**CITY OF SAN ANTONIO  
INTERDEPARTMENTAL MEMORANDUM  
PUBLIC WORKS DEPARTMENT**

SUBJECT: Hillside Acres Phase II, Field Alteration Number 5

# HILLSIDE ACRES DRAINAGE OUTFALL- PH. II

Field Alteration No. PW-5

1. Project Map
2. Field Alteration Request No. 5, Final

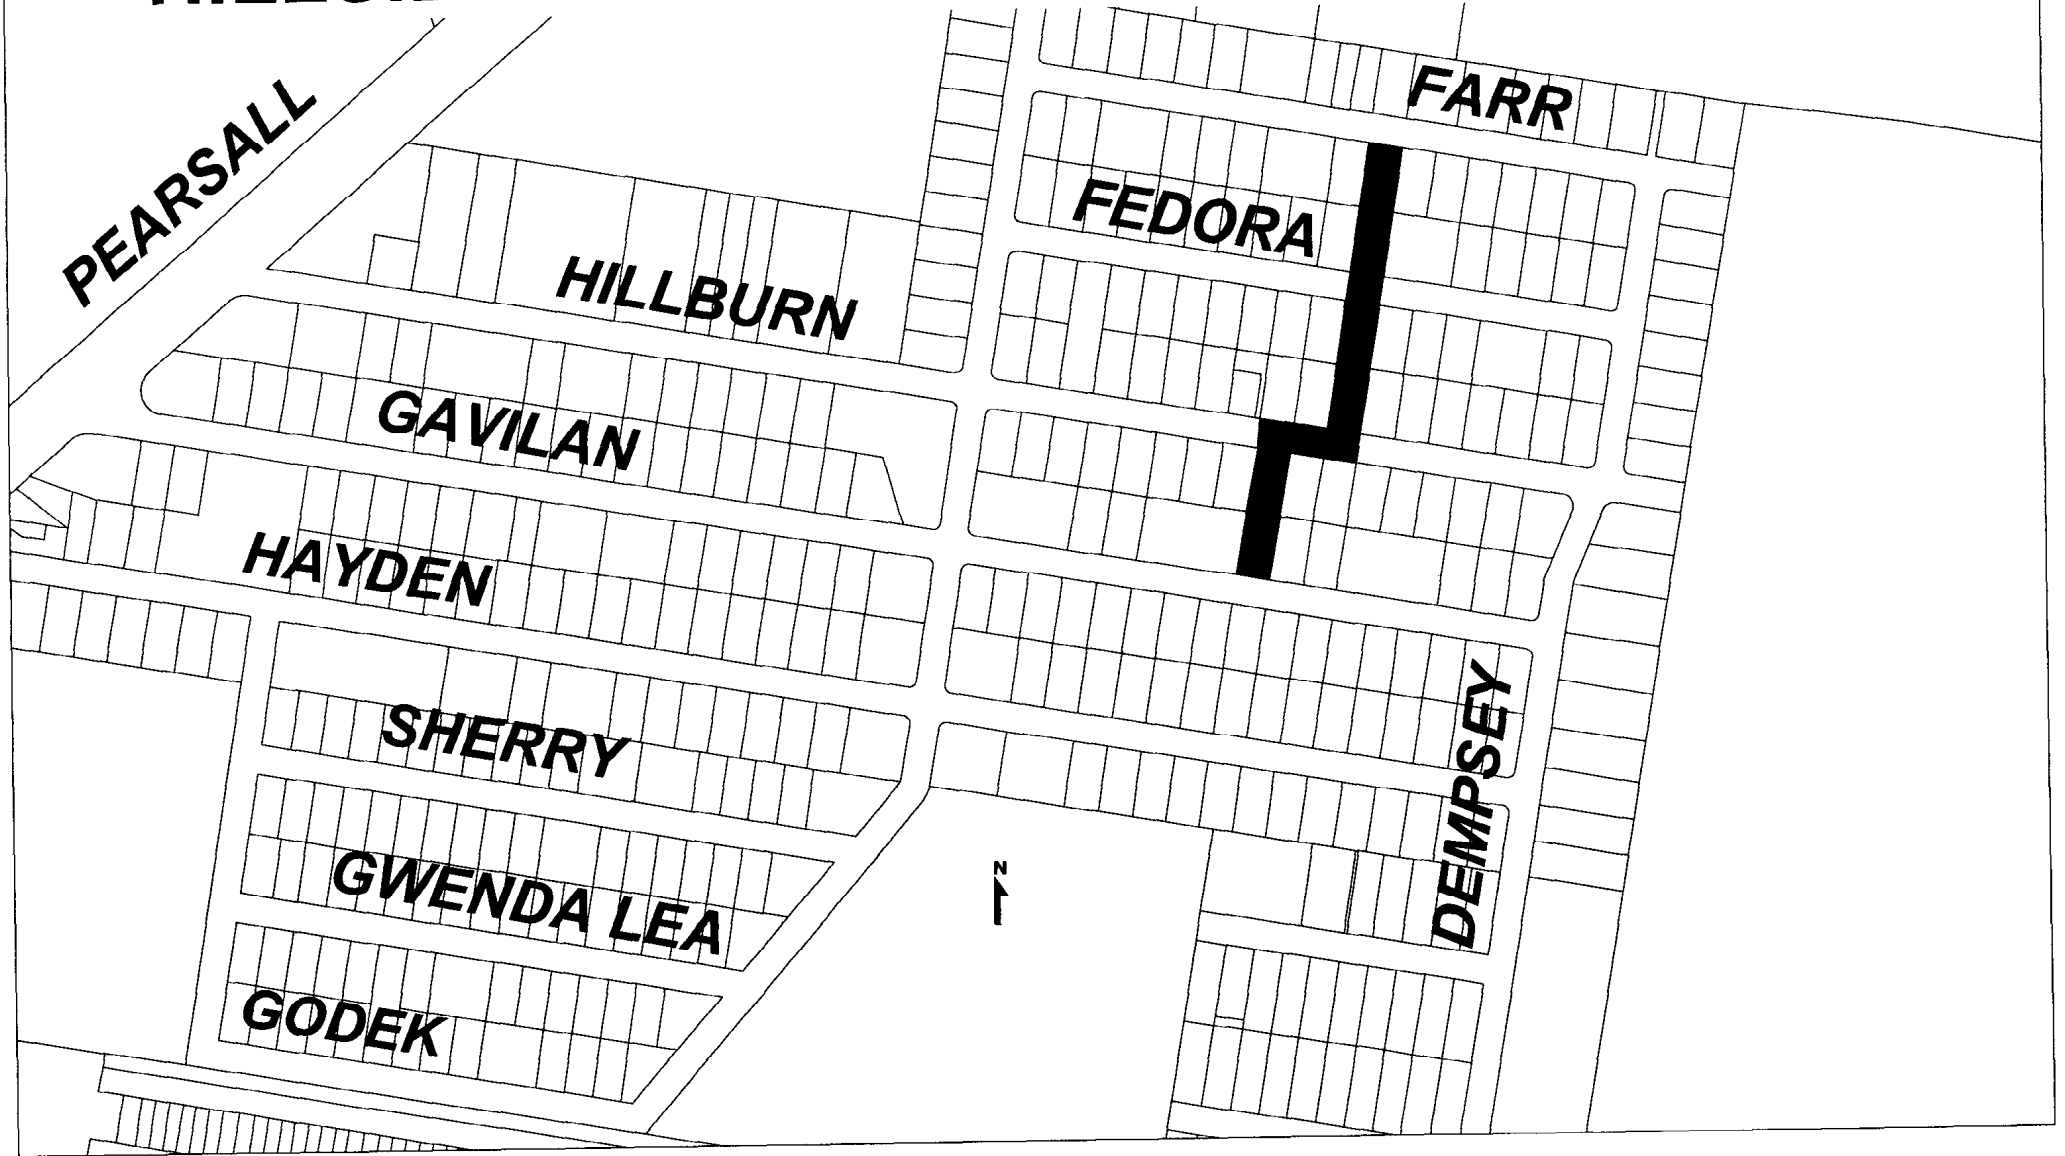
This Ordinance ratifies and authorizes Field Alteration Number 5, in the amount of \$26,352.80 which provides for asphalt treated base driveways, storm drainage pipe, Final Lift Type D asphalt pavement, gravel driveways, vehicular gate, Special Item number 1 – concrete headwall, and Special Item number 2 – restocking of pipe as shown in Attachment 1.

Items addressed in this Field Alteration include the increase in the asphalt treated base and the storm drainpipe quantities as some of the existing dirt residential driveways were much wider than shown in the plans and new driveways have been installed since the completion of the final plans. Final Lift Type D asphalt pavement was not included in the base bid quantities due to the street reconstruction portion of the project being proposed for completion at a later date. A vehicular gate was added to provide access to the drainage easement, and a concrete headwall was needed to retain the edge of the new asphalt driveway at 5214 Hillburn due to the close proximity to the edge of a 4-way inlet. The restocking fee included in the Field Alteration provides for the return of unused 36-inch storm drainpipe which was replaced with a 24-inch drainpipe to avoid engineering re-design and down-time charges.
